Publication 148

**Revisions to  
Traffic Standards – Signals TC-8800 Series  
December 2011 Edition, Change No. 2**

## **TRAFFIC STANDARDS—SIGNALS TC-8800 SERIES**

**DECEMBER 2011 EDITION**

TRAFFIC SIGNAL SUPPORT  
MAST ARM

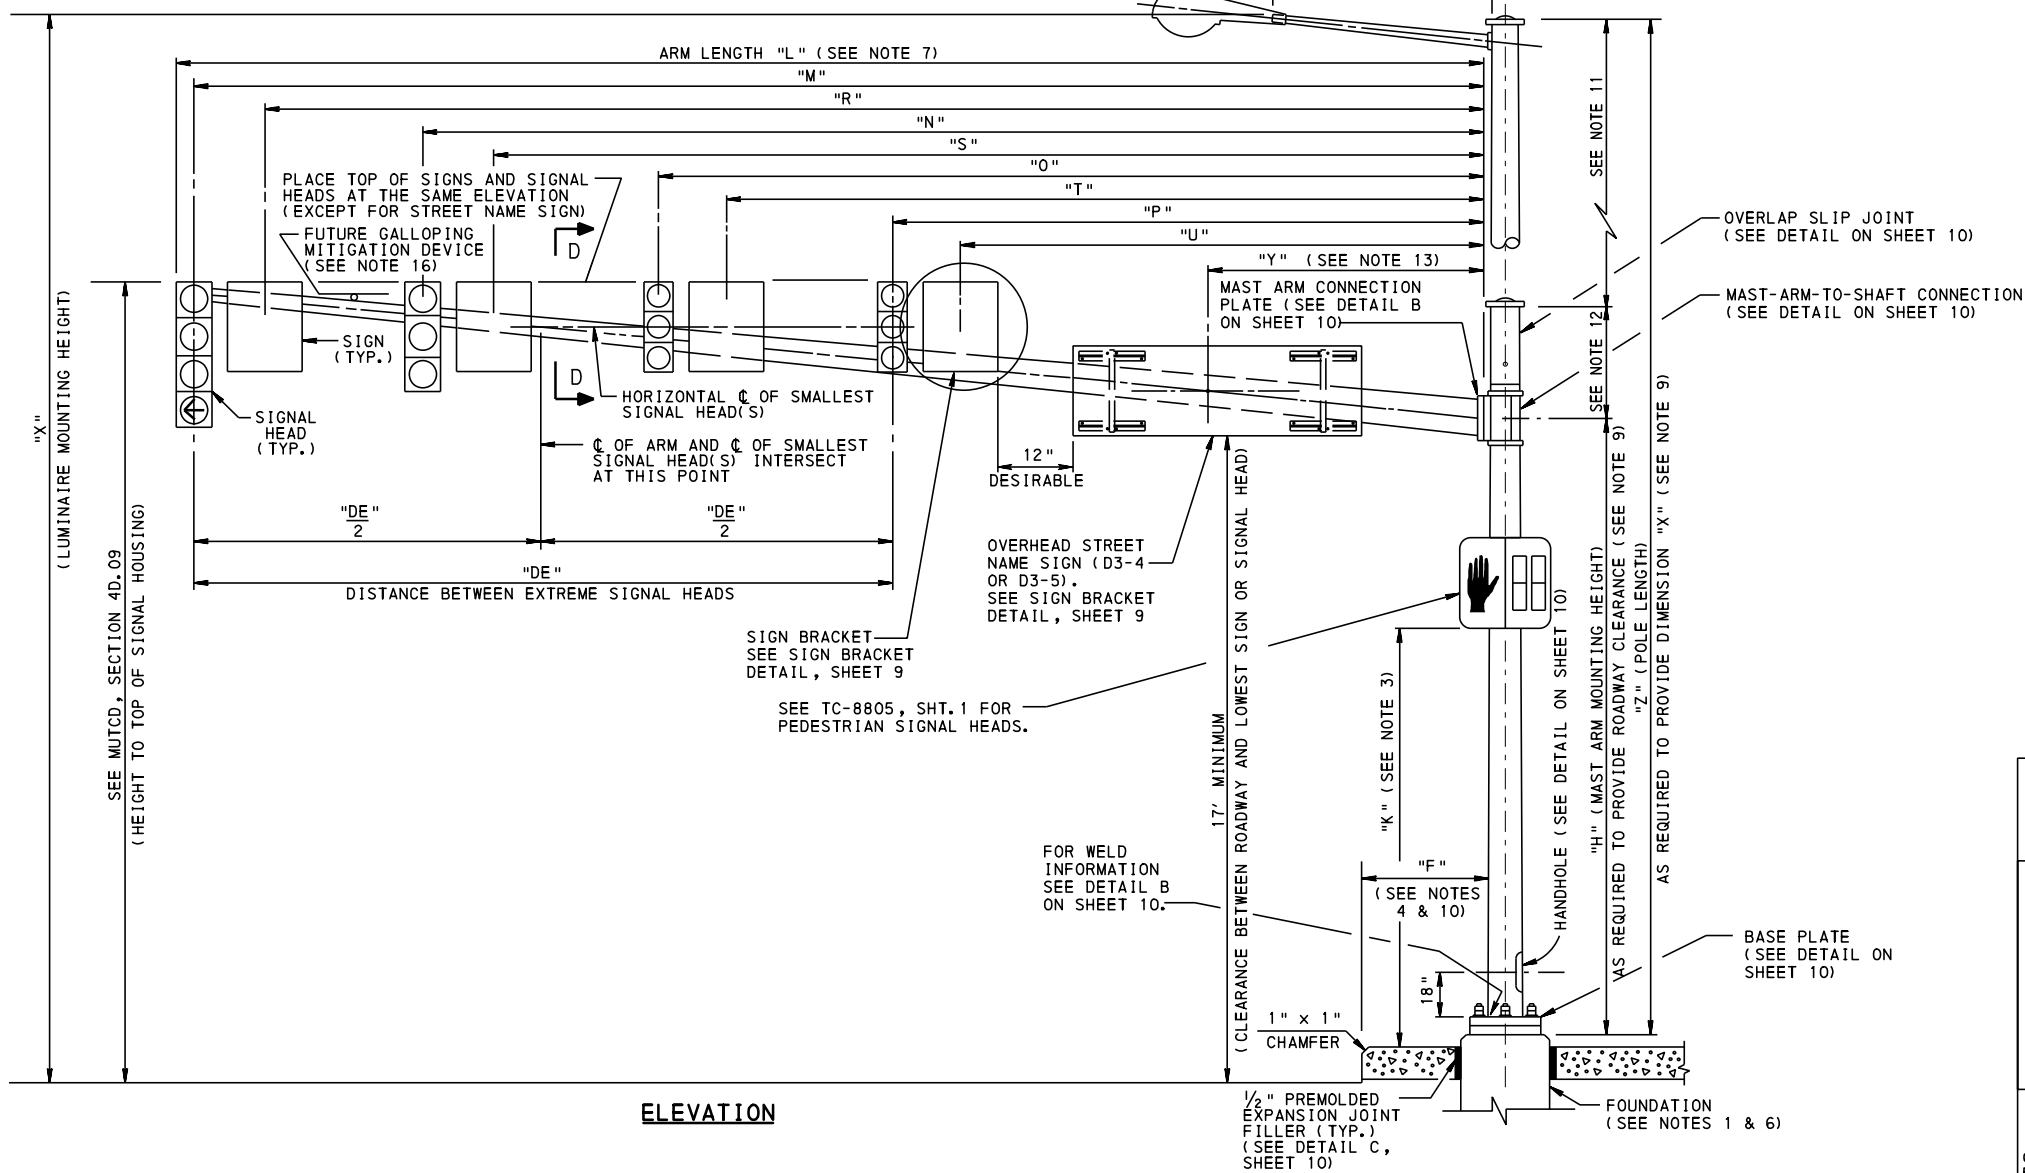
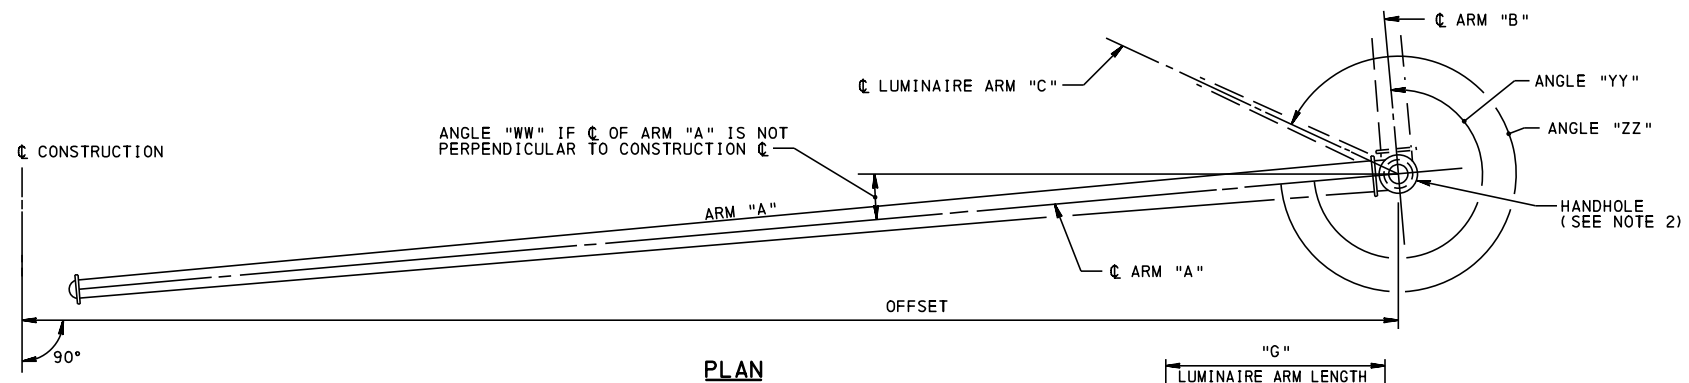
STANDARD	SHEET	DESCRIPTION OF CHANGES
TC-8801	1	<p>Updated Mast Arm Details as follows:</p> <p>Updated Plan View of mast arm as follows:</p> <ul style="list-style-type: none"> <li>• Revised from “Angle “W” IF centerline OF ARM IS NOT PERPENDICULAR TO CONSTRUCTION centerline” to “Angle “WW” IF centerline OF ARM IS NOT PERPENDICULAR TO CONSTRUCTION Centerline”</li> <li>• Revised from “Angle “Y”.”. to “Angle “YY””</li> </ul> <p>Updated Elevation View of mast arm as follows:</p> <ul style="list-style-type: none"> <li>• Revised depiction of the Signal head (TYP.) from a 3-section vehicular signal to a 4-section signal head.</li> <li>• Added “SEE MUTCD, SECTION 4D.09 (HEIGHT TO TOP OF SIGNAL HOUSING).” Detail Reference.</li> <li>• Revised from ““H” (CLEARANCE BETWEEN ROADWAY AND LOWEST SIGN OR SIGNAL HEAD) (SEE NOTE 10)” to “17’ MINIMUM (CLEARANCE BETWEEN ROADWAY AND LOWEST SIGN OR SIGNAL HEAD).”.-Removed “(SEE NOTE 10)” callout.</li> </ul>

STANDARD  
TRAFFIC SIGNAL SUPPORT  
STRAIN POLE

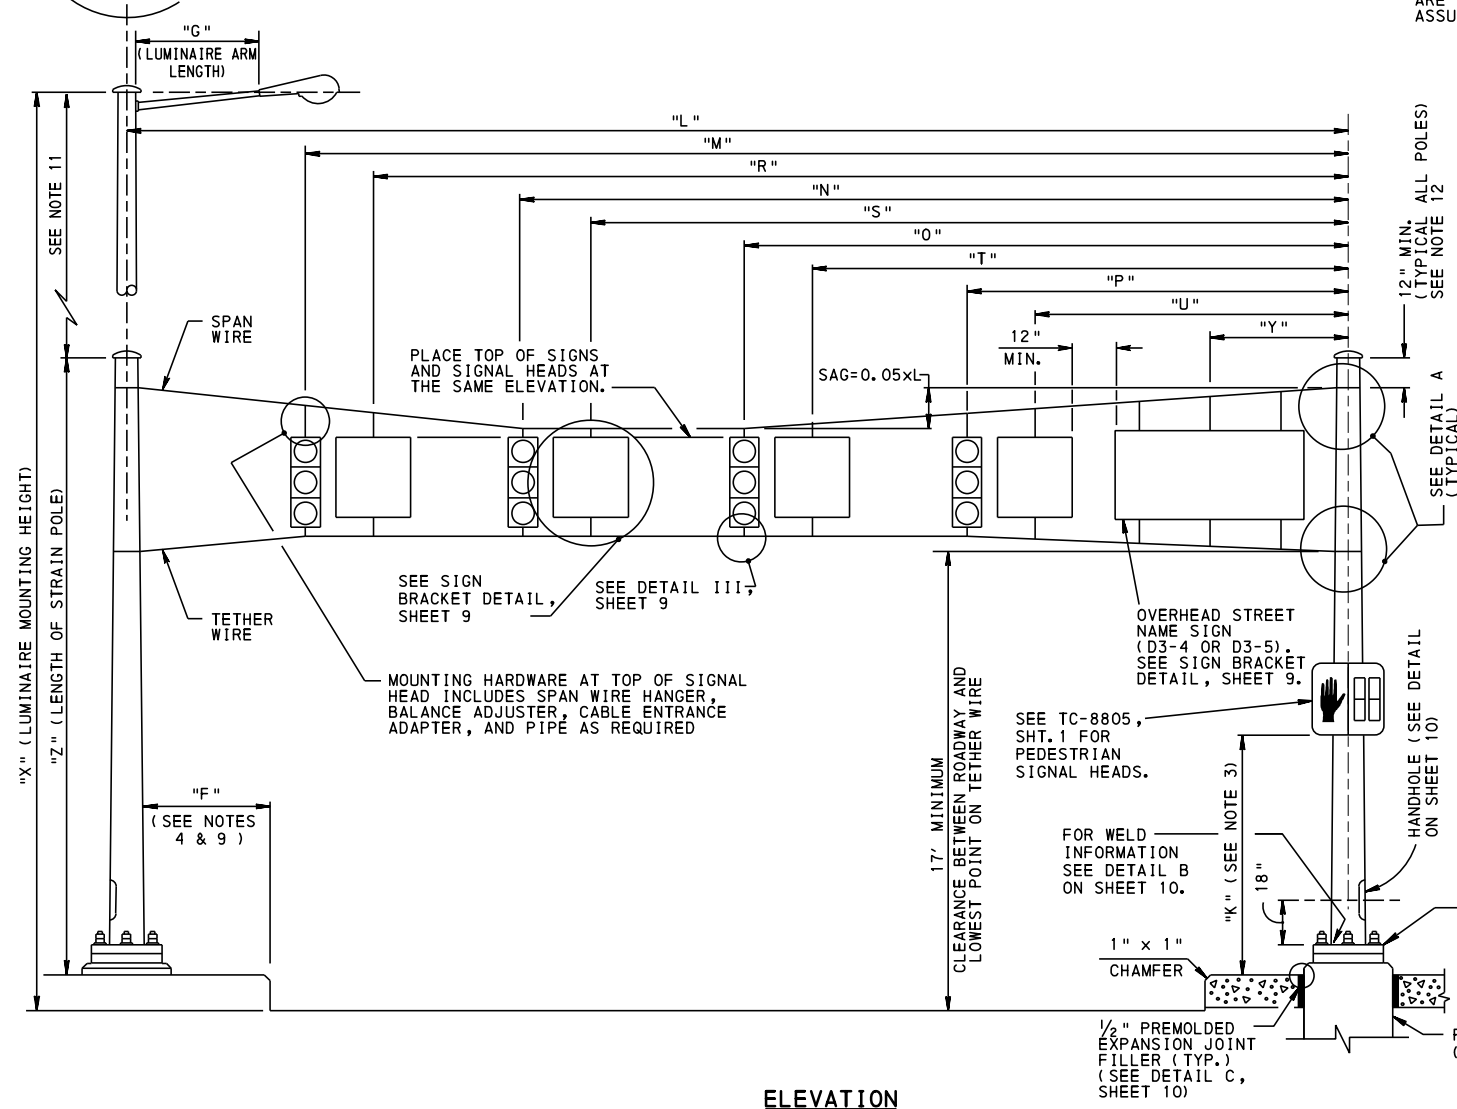
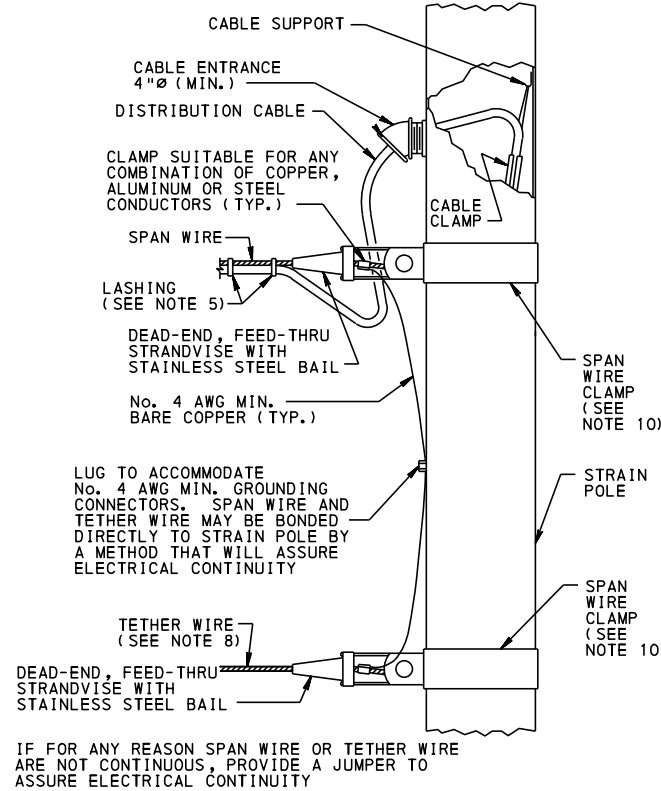
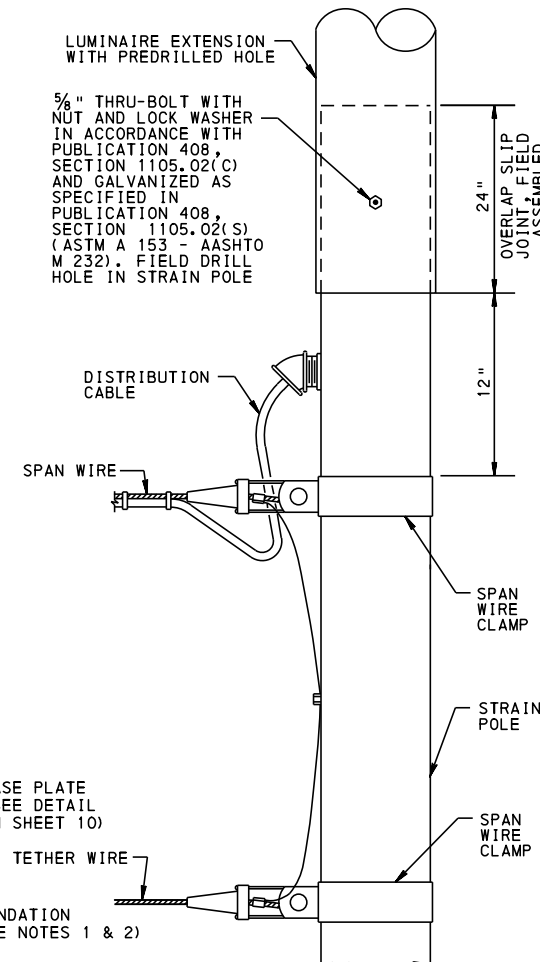
TC-8801	2	<ul style="list-style-type: none"> <li>Revised from “AS REQUIRED TO PROVIDE DIMENSION “H” (SEE NOTE 9)” to “H” (MAST ARM MOUNTING HEIGHT.”. - Removed “(SEE NOTE 9)” callout.</li> </ul> <p>Updated Strain Pole Details as follows:</p> <p>Updated Elevation View of strain pole as follows:</p> <ul style="list-style-type: none"> <li>Revised from “Angle “Y”” to “Angle “YY””</li> <li>Revised from “Angle “Z”” to “Angle “ZZ””</li> <li>Revised from “15’ MNIMUM (SEE NOTE 9)” to “17’ MINIMUM CLEARANCE BETWEEN ROADWAY AND LOWEST POINT ON TETHER WIRE.”. -Removed “(SEE NOTE 9)” callout.</li> </ul>	
TC-8801	3	<p>Updated Anchor Bolt Detail as follows:</p> <ul style="list-style-type: none"> <li>Depicted a washer underneath of the leveling nut</li> </ul>	
TC-8801	4	<p>Updated Traffic Signal Support Foundation Type A - Notes as follows:</p> <ul style="list-style-type: none"> <li>Added Note 8 – “EMBANKMENT SLOPE AS ILLUSTRATED IN PUBLICATION 72M (RC-83M) SHEET 3 OF 3. 2:1 MAXIMUM SLOPE. STEEPER SLOPES REQUIRE SPECIAL DESIGN.”.</li> </ul>

**CONNECTION DETAIL**

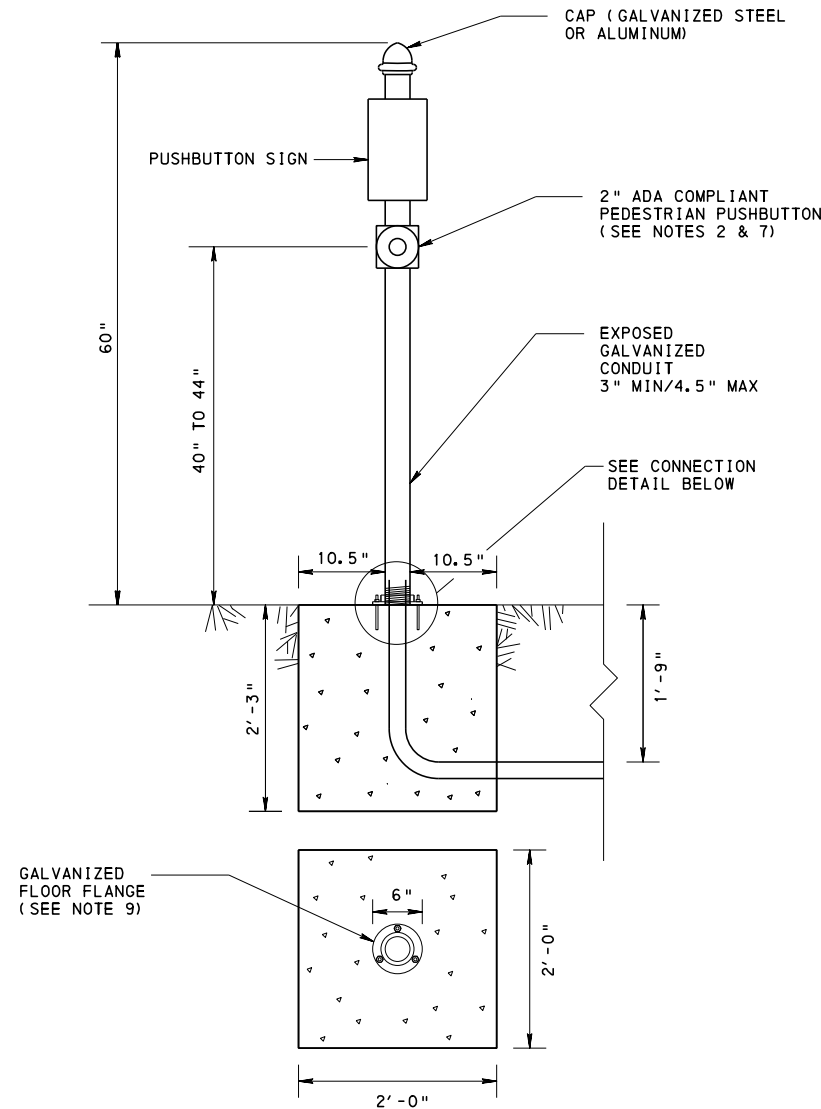
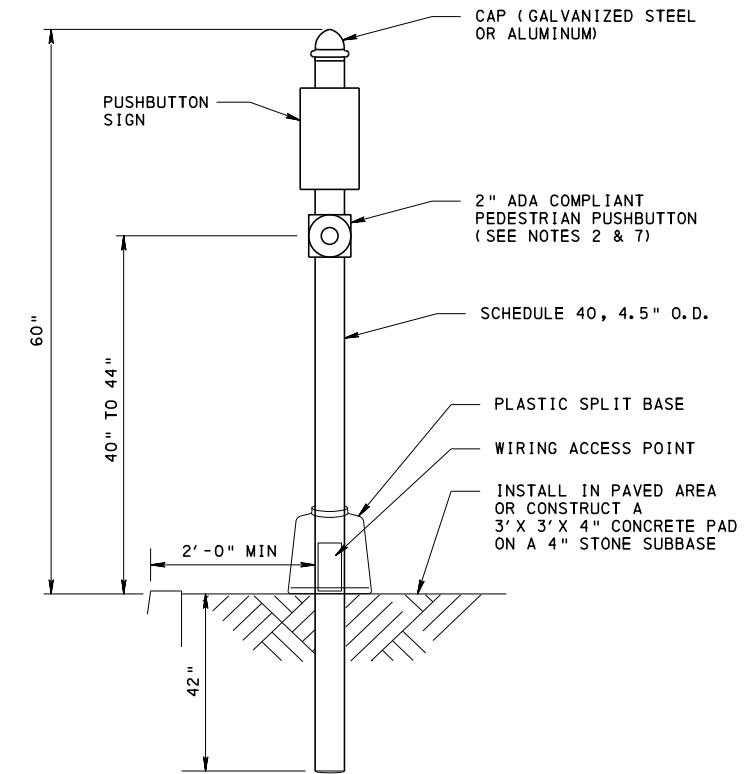
TC-8803	3	<ul style="list-style-type: none"> <li>• Added Note 9 – “USE AN APPROPRIATELY SIZED FLANGE TO CORRESPOND WITH THE POLE SIZE THAT IS SELECTED. CONNECTION DETAIL CORRESPONDS TO 3” POLE.”.</li> <li>• Added Note 10- “FOR TYPE A AND B FOUNDATIONS, CONDUIT INSTALLATION IN CONCRETE BLOCKS SHALL BE CENTERED AND AS SPECIFIED IN DIMENSIONS.”.</li> </ul> <p>Updated Pedestrian Pushbutton Mounting Details Type D and Type E as follows:</p> <p>-Revised “EXPOSED GALVANIZED CONDUIT” callout to “EXPOSED GALVANIZED CONDUIT 3” MIN/4.5” MAX.”.</p> <p>- For type D and E Foundations View A-A - Added- “SEE NOTE 9.”.</p> <p>Updated Notes as follows:</p> <ul style="list-style-type: none"> <li>• Added Note 9 – “USE AN APPROPRIATELY SIZED FLANGE TO CORRESPOND WITH THE POLE SIZE THAT IS SELECTED. VIEW A-A DETAIL CORRESPONDS TO 3” POLE.”.</li> </ul>	
TC-8804	1	<p>Updated Service Type A and B Details as follows:</p> <p>Revised “2” CONDUIT (MIN.)” callout to “CONDUIT (SIZE PER UTILITY.”.</p> <p>Updated Notes as follows:</p> <ul style="list-style-type: none"> <li>• Revised Note 5 from “PROVIDE ALL SERVICE CONDUITS OF THE HDG RIGID METALLIC TYPE WITH WATERTIGHT CONDUIT HUBS” to “PROVIDE ALL SERVICE CONDUITS OF THE MATERIAL APPROVED BY THE UTILITY AND ENSURE WATERTIGHT”.</li> </ul>
